**Response To:
The Columbia River Impact
Evaluation Plan
DOE/RL-92-28, Rev. 0**

Nez Perce Tribe

September 3, 1993

The DOE/RL-92-28 REV. 0 Columbia River Impact Evaluation Plan was reviewed by the Nez Perce Tribe Department of Environmental Restoration and Waste Management in accordance with the government-to-government agreement between the U. S. Department of Energy and the Nez Perce Tribe.

Figure 2-1. Hanford Site

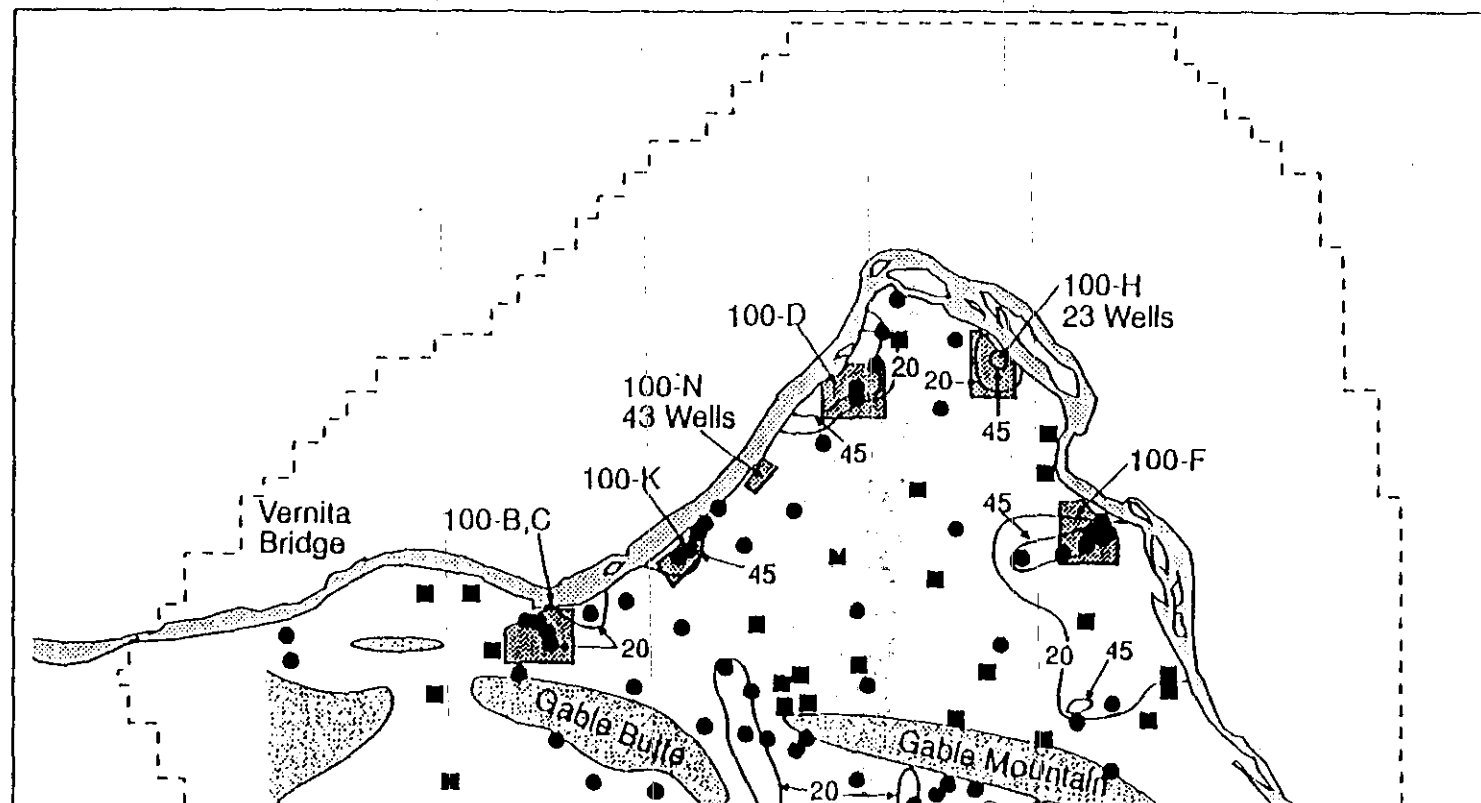
The Nez Perce ERWM notes that the legend is not complete. This map of the Hanford Site is inappropriate to use if sites such as the McNary Dam and the Priest Rapids Dam are referenced (Page 5: Paragraph 3: Sentence 1). The arrow above the words "YAKIMA RIVER" is very misleading. What does it indicate secondary wind direction, north, or current flow? The arrow near the words COLUMBIA RIVER has the same effect as the previously mentioned arrow. The arrows are not listed in a legend box, along with typical map items such as bridge symbols, boundary symbols, and feature pointers. This is not standard cartographic nomenclature. Because there are islands depicted in the river channel

there should be some references to the current flow and sediment transport patterns. The earlier reference to Page 5: Paragraph 4: Sentence 5 states that the area is important for spawning salmon and steelhead fish.

Figure 2-3. Nitrate (NO_3) Concentrations In the 100 Area Unconfined Aquifer, 1990.

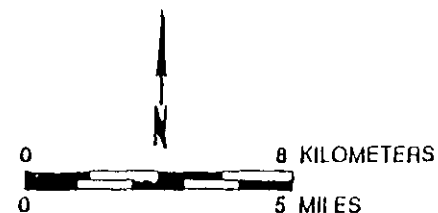
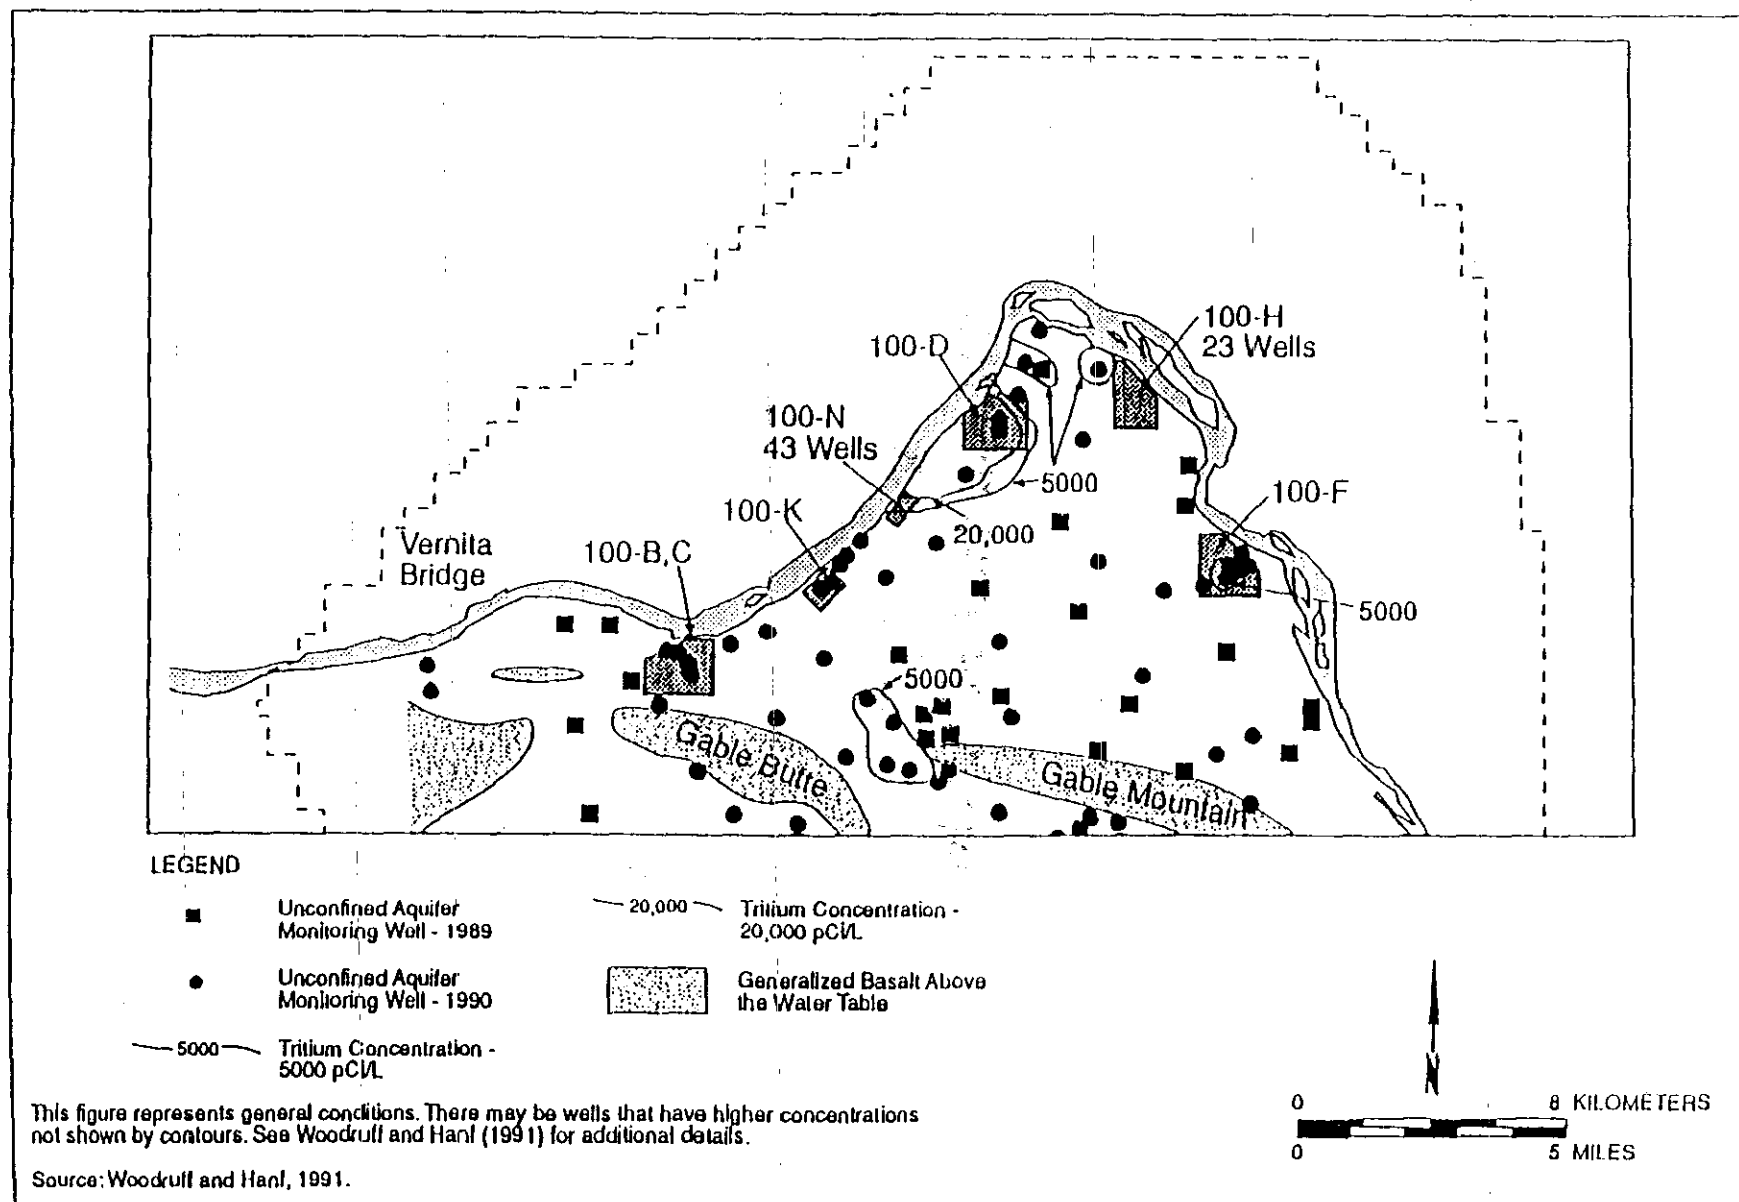
The Nez Perce ERWM observes that the legend is incomplete. A solid line is an indicator of a high degree of certainty to within meters, yet the wells which provide the controls are up to kilometers apart. There is a dilution error by using wells not in the suspected plume.

Figure 2-5. Relative Plume Locations and Projected Flow Directions Along the Hanford Reach.

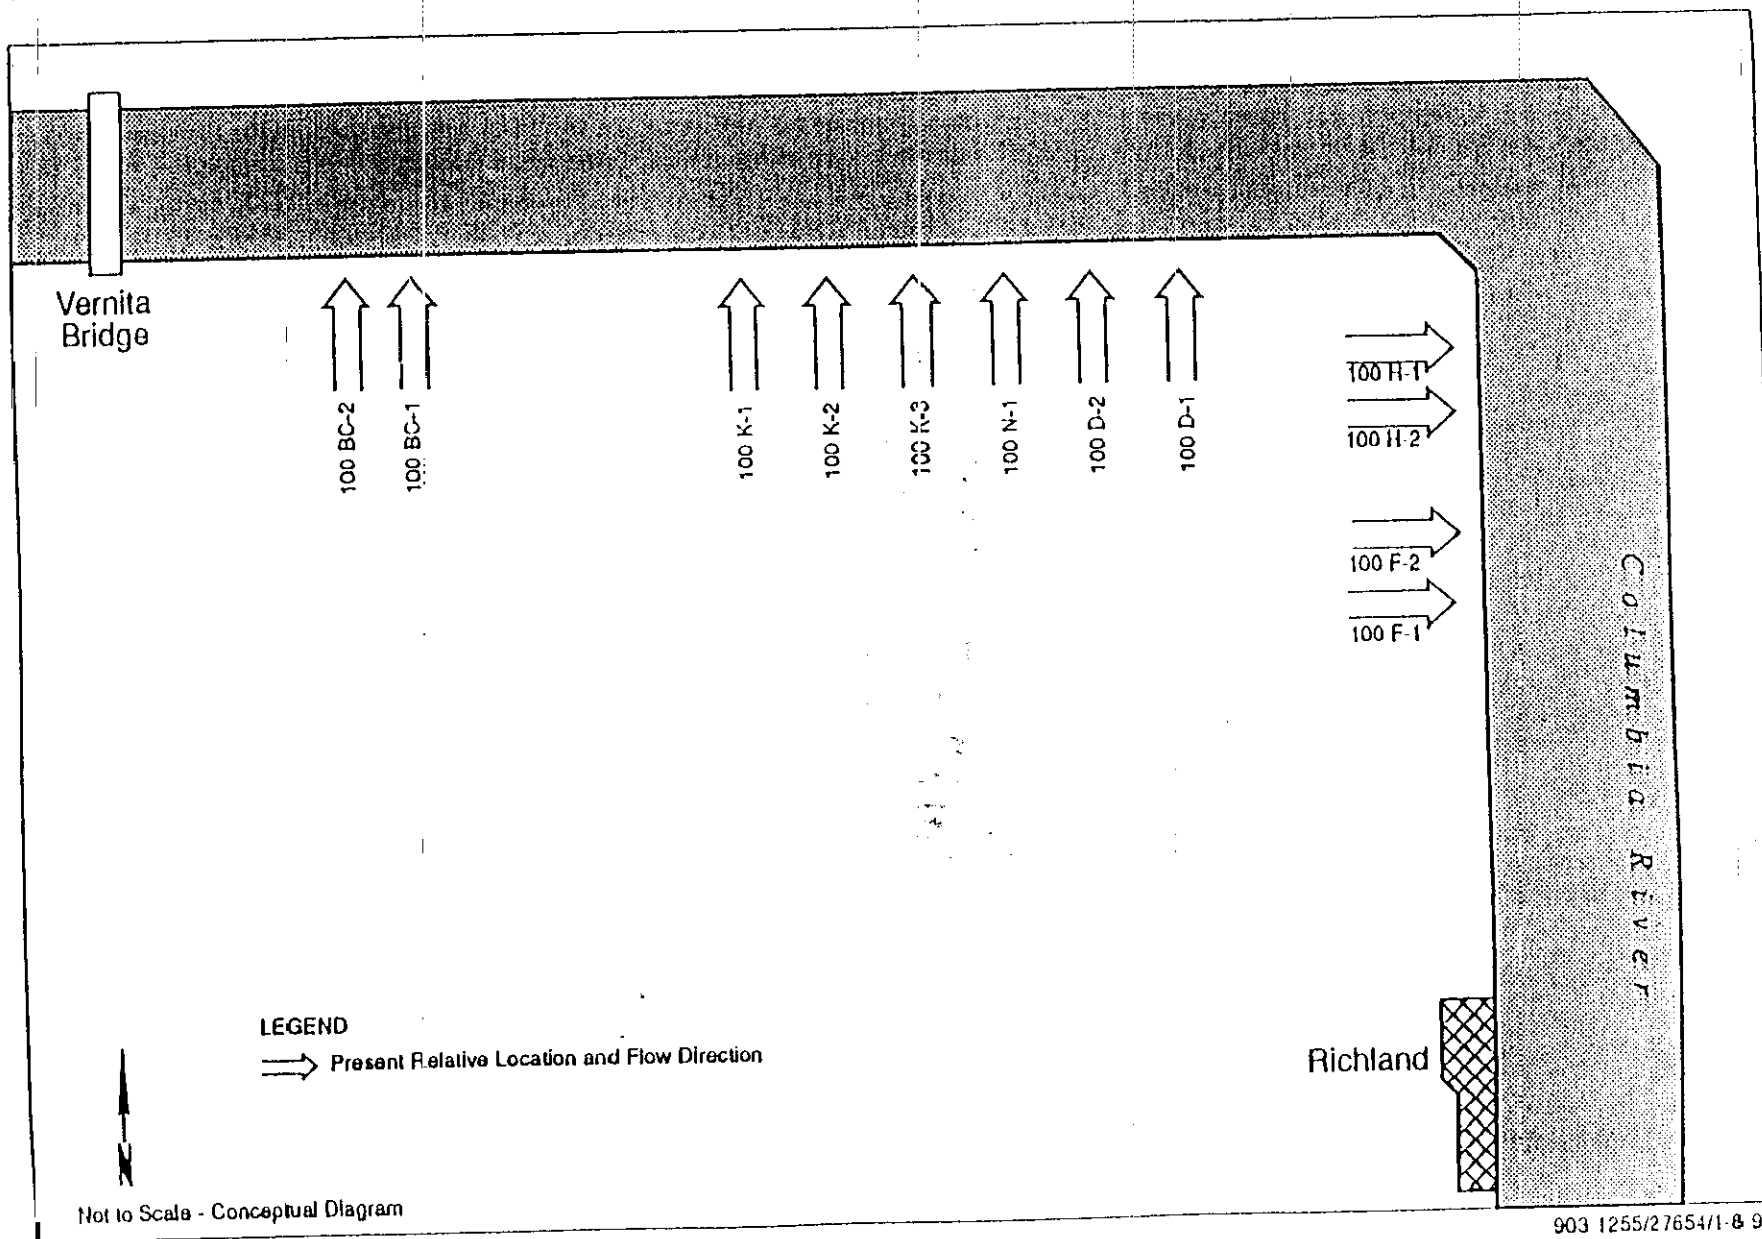
The Nez Perce ERWM asks if this picture is too simplistic for use in a document dealing with endangered species. This is an inadequate characterization that doesn't accomplish the flow directions from the gradient contours (Page B-4 Figure B-3).

Figure 2-7. ^3H and ^{90}Sr Concentrations in the Columbia River Since Reactor Shutdown.

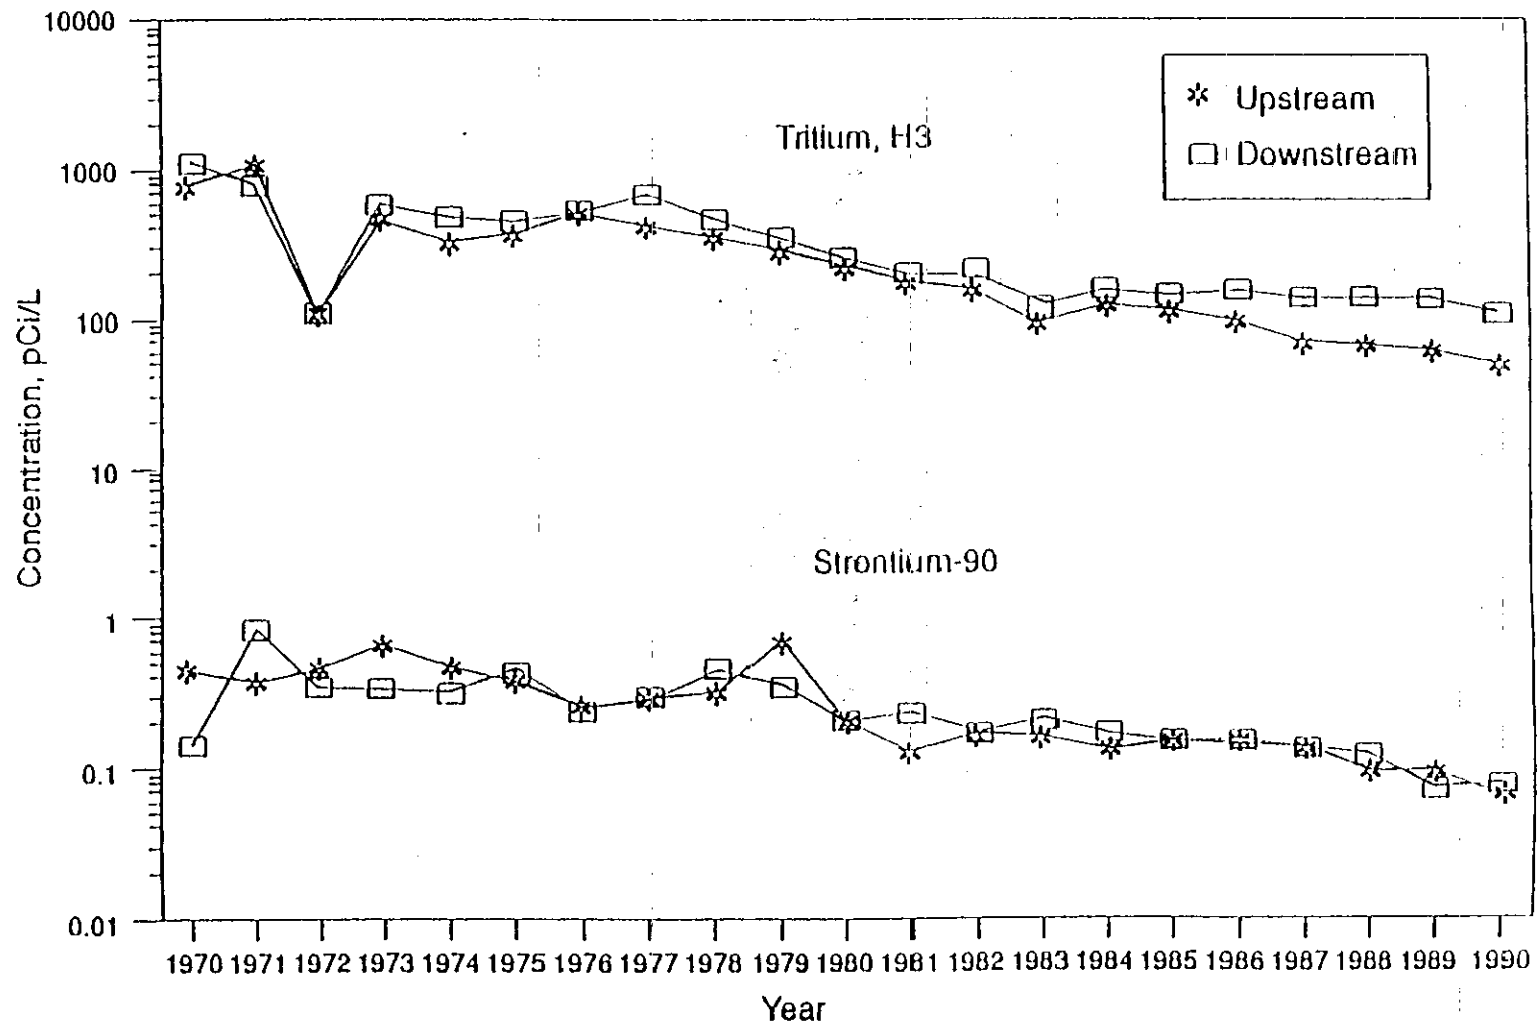
Because there are admitted gaps in the data collection (Page 24: Paragraph 3: Sentences 3 and 4) the sampling methodology is in question. What is important is not the "quantitative" view but the qualitative view, i.e. the overall concentration is important.

Figure 2-8. Total Uranium in the Columbia River Since Reactor Shutdown.

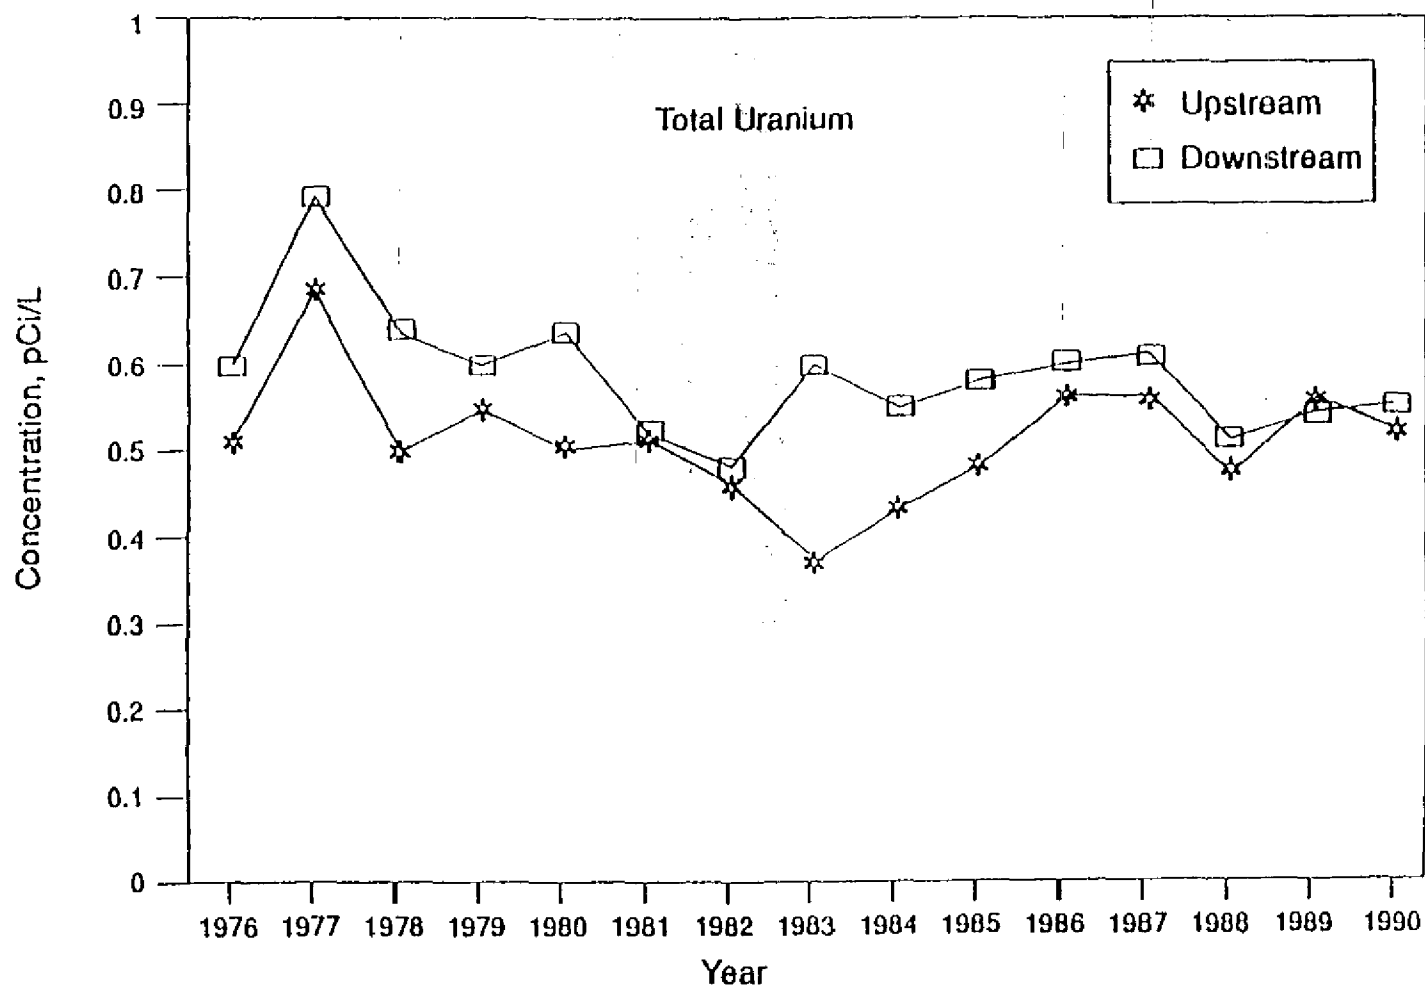
The 1990 concentration amount is not significantly different from the 1976 concentration amount. Why have the decay products not been taken into account? The Nez Perce ERWM notes that Figure 2-8 seems to demonstrate no significant decreasing trend in total uranium, in contrast to the statement on Page 24: Paragraph 2: Sentence 2: Bullet 1.
